**Redevelopment of the Lake Macquarie Yacht Club  
Ada Street, Belmont**

**MP 08\_0045 MOD 1**

**Modification to Staging**

Director-General's  
Environmental Assessment Report  
Section 75W of the  
*Environmental Planning and Assessment Act 1979*

Figure 3: Lake Macquarie Yacht Club redevelopment project (as approved)

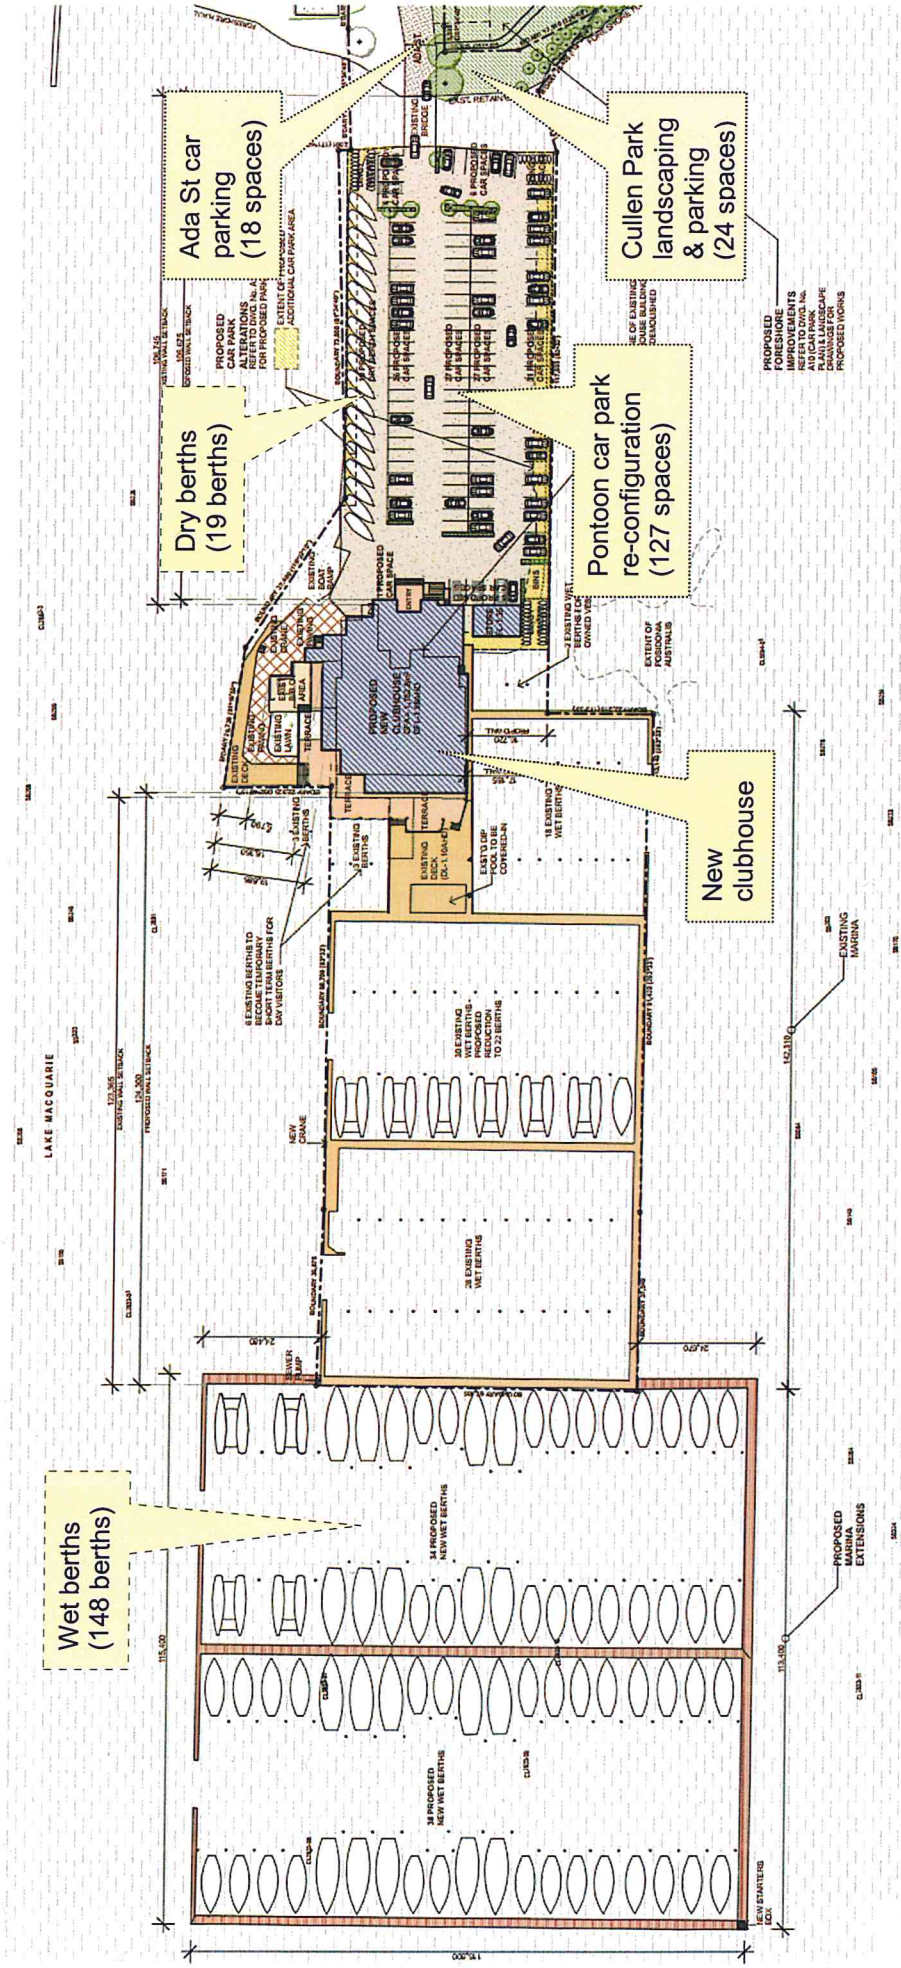
The staging of construction under the existing approval is as follows:

Stage 1

- extension of the existing marina to accommodate 64 additional wet berths (148 total);
- reconfiguring of existing berths and the surrender of four (4) commercial swing moorings (reduced to eight);
- reconfiguration of car parking on the existing pontoon to provide a total of 127 car parking spaces;
- public domain improvements to Cullen Park, including provision of 24 car parking areas and landscaping improvements;
- provision of 18 car spaces on the southern side of Ada Street; and
- provision of infrastructure and services associated with the new facilities.

Stage 2

- demolition of existing club house and erection of new club house;
- construction of 19 hardstand dry berths; and,
- provision of infrastructure and services associated with the new facilities.

Figure 4: Proposed Stage 1

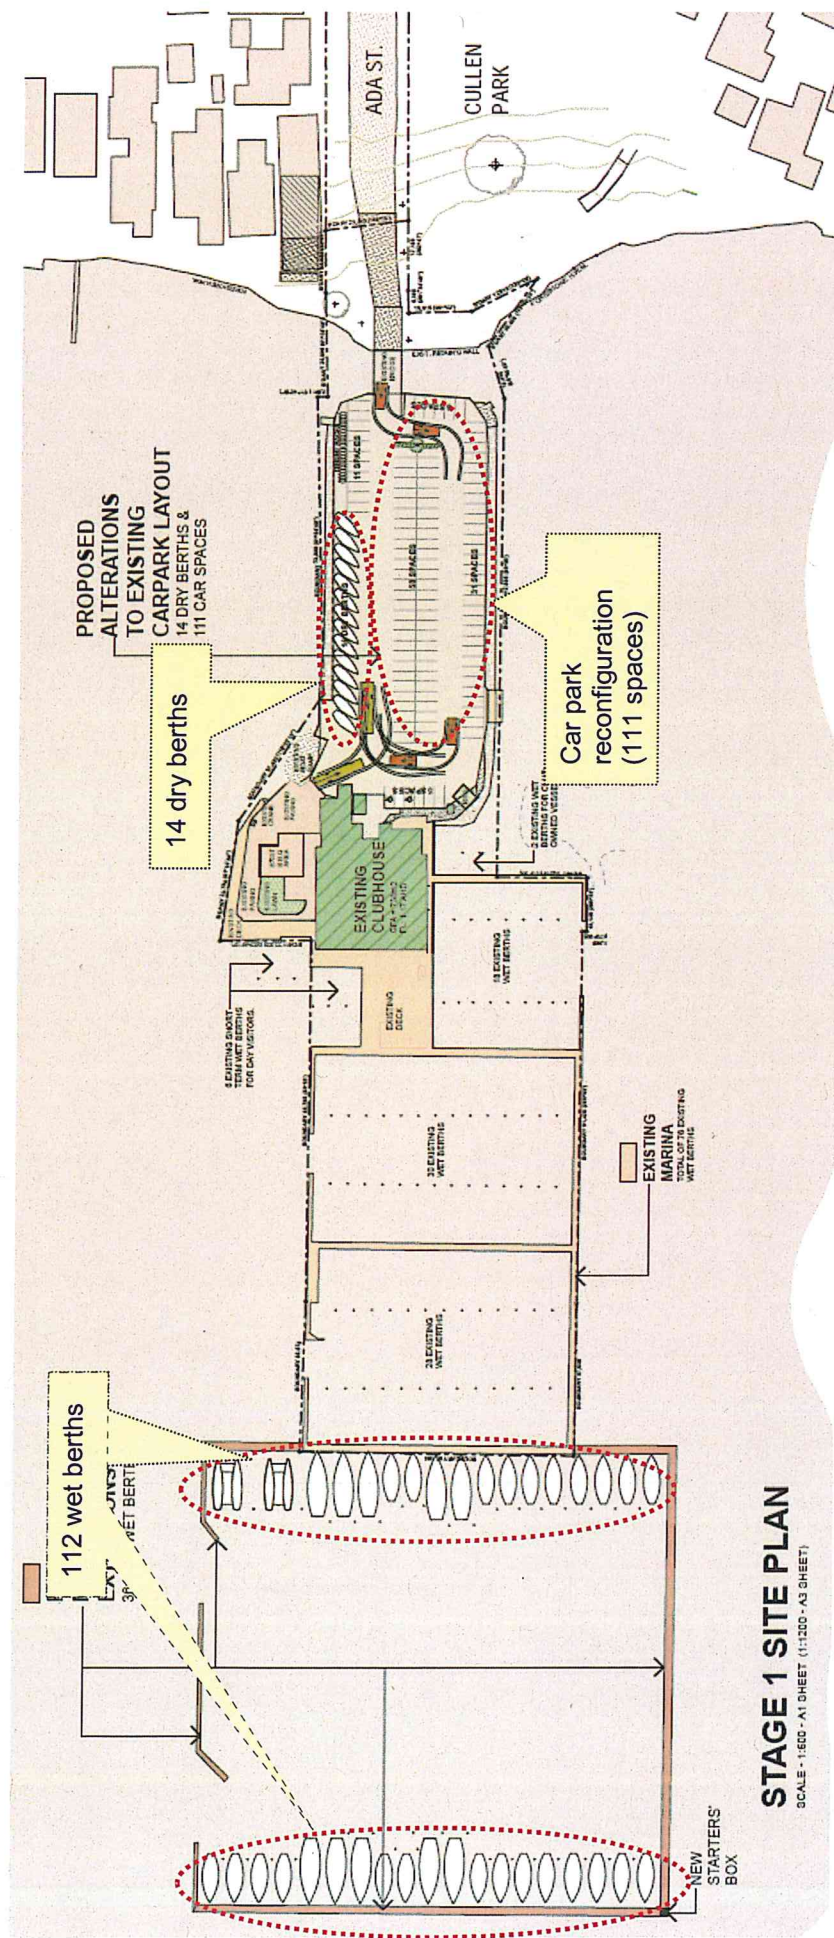
- reduce the overall number of wet berths to be constructed from 148 to 112;
- construct 14 hardstand dry berths;
- reconfigure car parking on the existing pontoon to accommodate 111 spaces; and,
- provide infrastructure and services associated with the new facilities (refer to Figure 4).

**Figure 5: Proposed Stage 2**

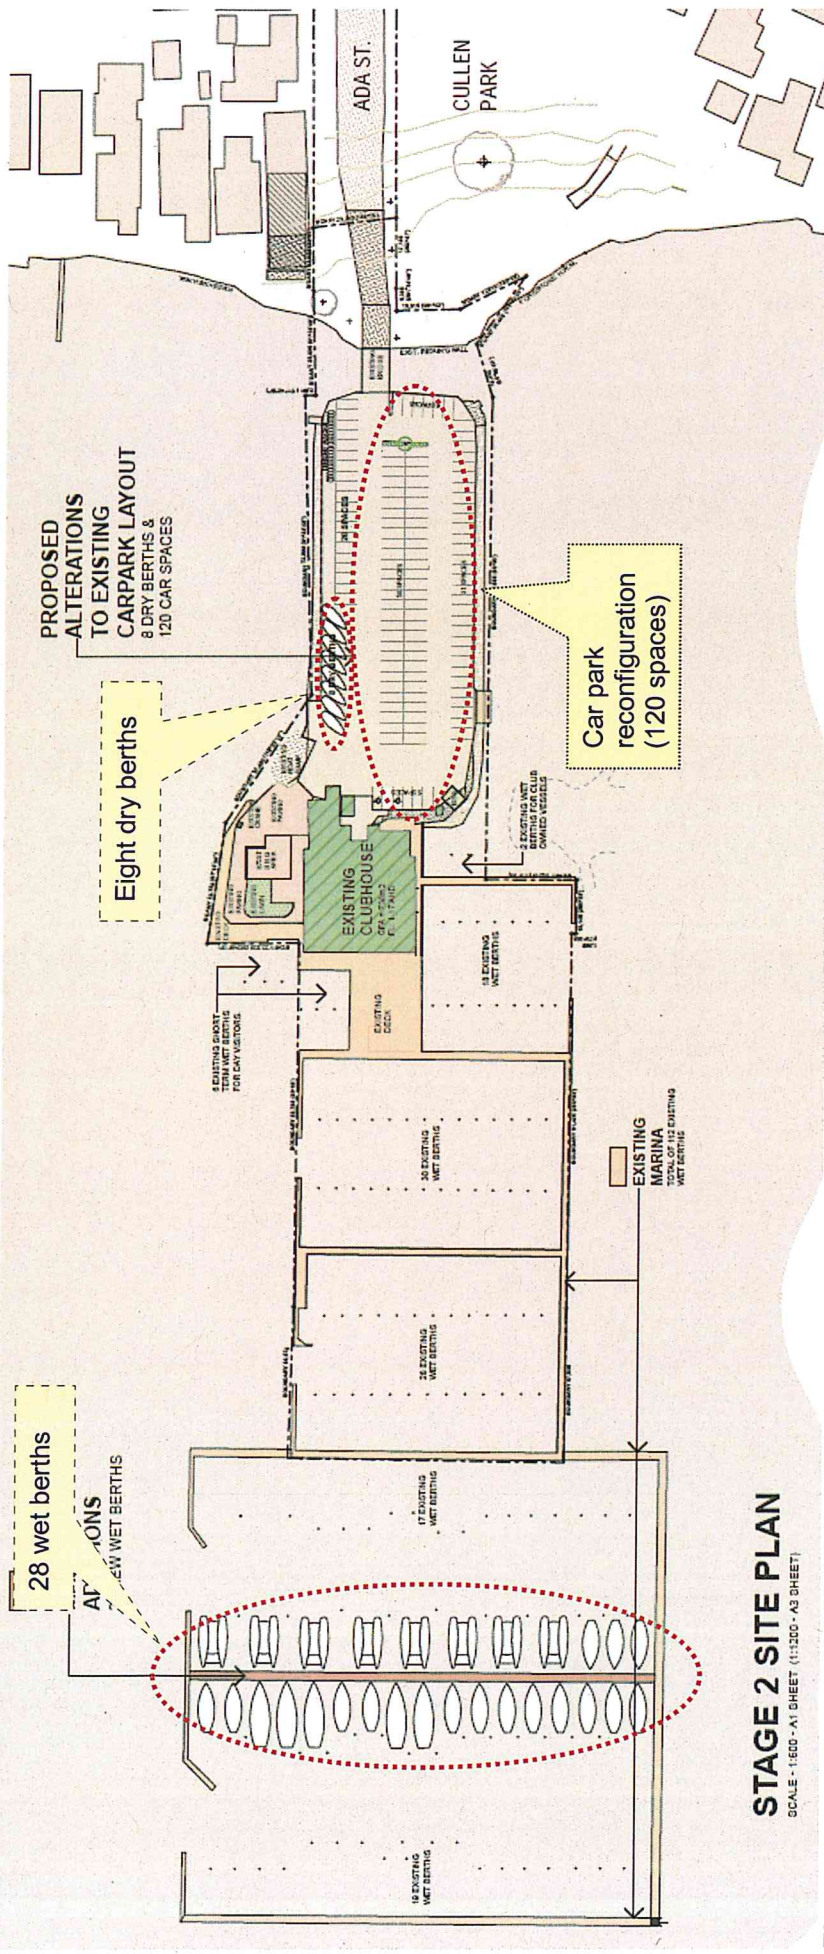
- construct the central finger of the new marina resulting in 28 wet berths;
- reduce the number of hardstand dry berths of from 14 to eight (8);
- provide infrastructure and services associated with the facilities; and,
- reconfigure car parking on the existing pontoon to increase parking from 111 to 120 spaces (refer to **Figure 5**).

Figure 7: Proposed Stage 4

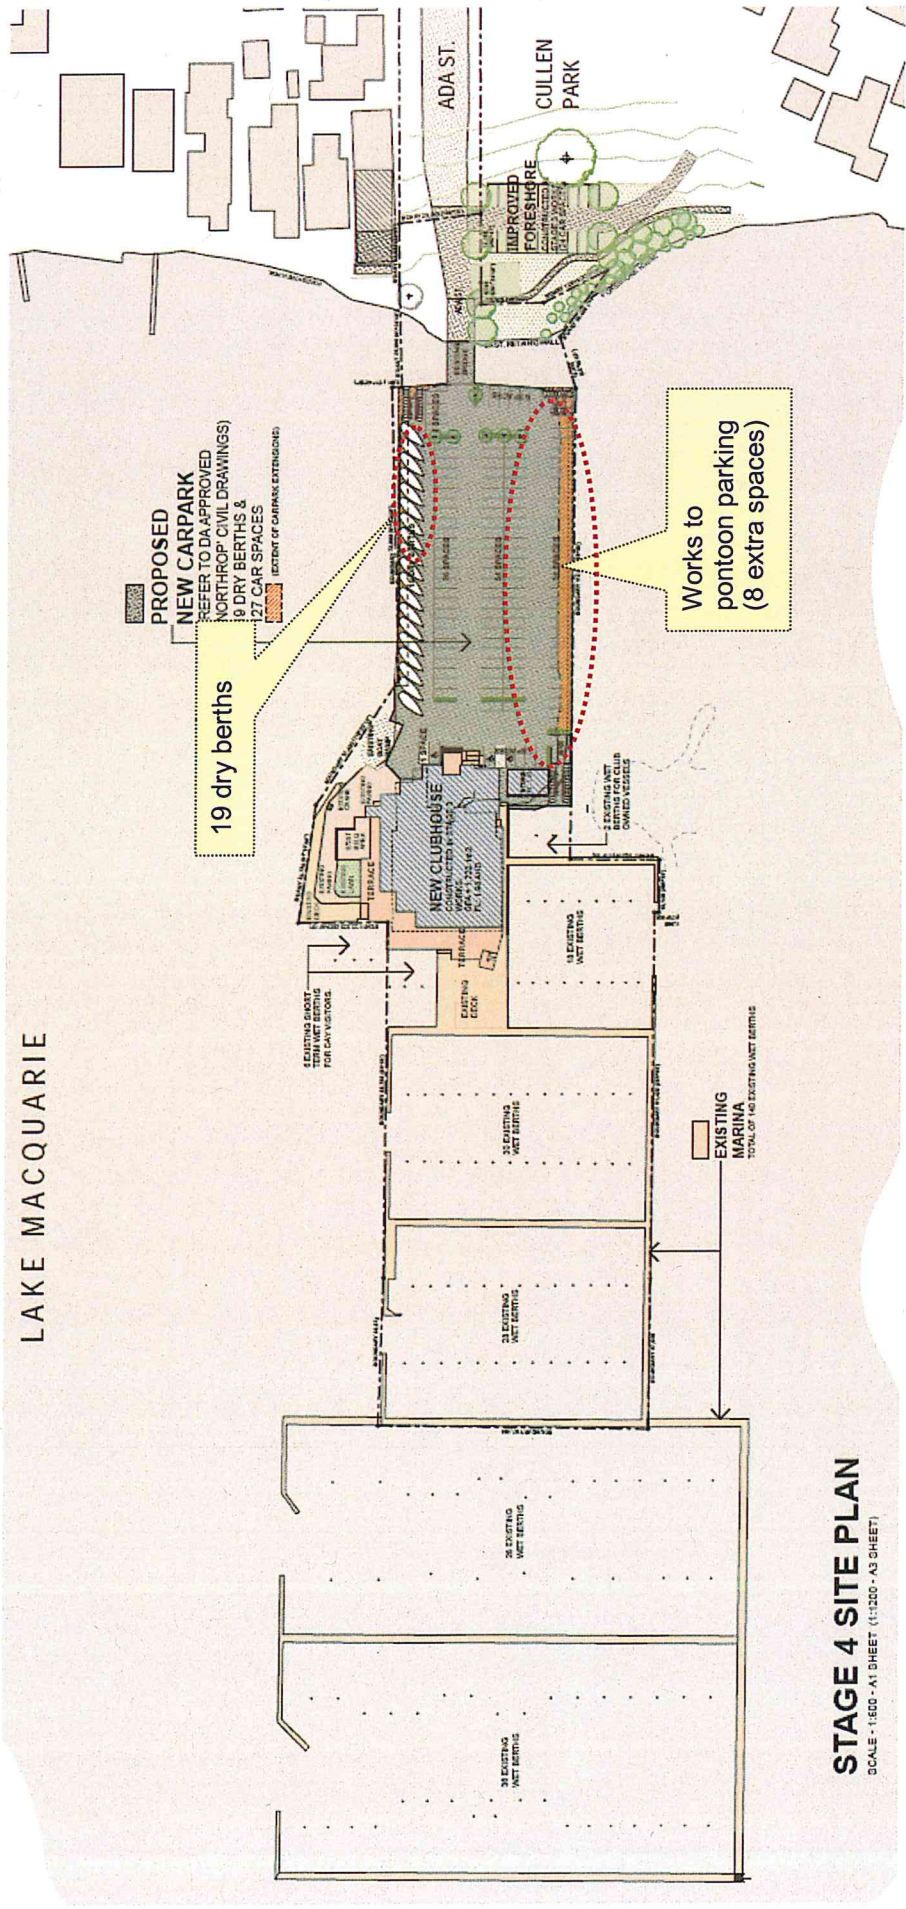
- carry out works to pontoon car parking area to increase parking from 119 to 127 spaces; and,
- increase number of hardstand dry berths from seven (7) to 19 (refer to Figure 7).
